UNITED STATES PATENT AND TRADEMARK OFFICE

Office Action Summary

10/759,491

DETAILED ACTION

Chiu, Figure 3A

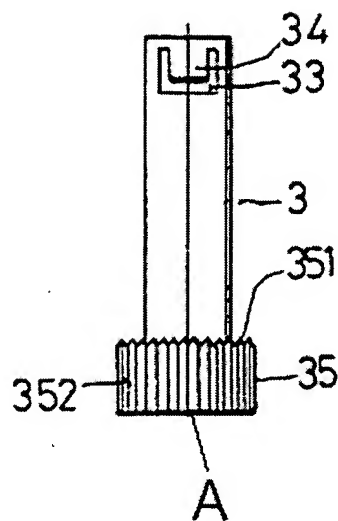
5. Claims 1-5, 11, and 13-16 are rejected under 35 U.S.C. 103(a) as being unpatentable over Park et al. in US Publication 2002/0074032 in view of Chiu in US Patent 5062178. Park teaches a collapsible canopy frame having a plurality of elongated side poles (37) having a side and an end and a plurality of wheel assemblies (39). Park fails to teach that the wheel assemblies have a mounting post. Chiu teaches a wheel assembly having a wheel (1) and a mounting post (2) extending transverse to the pole (4) on which it is supported. Chiu further teaches that the wheel assembly is

removably supported on the pole (the fact that the wheel is not integral to the pole is sufficient to indicate removability), that the mounting post extends through the side of the pole (through hole 411), that the assembly further comprises a bracket comprising a foot bracket (3), the bracket having an opening (in 35) aligned with an opening (411) in the pole, that the mounting post is removably secured in the bracket (the fact that the mounting post is not integral to the bracket is sufficient to indicate removability). Chiu further teaches that the foot bracket comprises a first side surface (33) and a second side surface (A), the first side surface having a first opening (31) therethrough, receiving the mounting post (Best seen in Figure 4) and including at least one resilient tongue (32) which engages a recess (21) in the mounting post. It would have been obvious to one of ordinary skill in the art at the time of invention to modify the device of Park et al. by using an assembly as taught by Chiu to attach a wheel to each of the poles of the canopy device in order to provide a removable wheel assembly for the user.
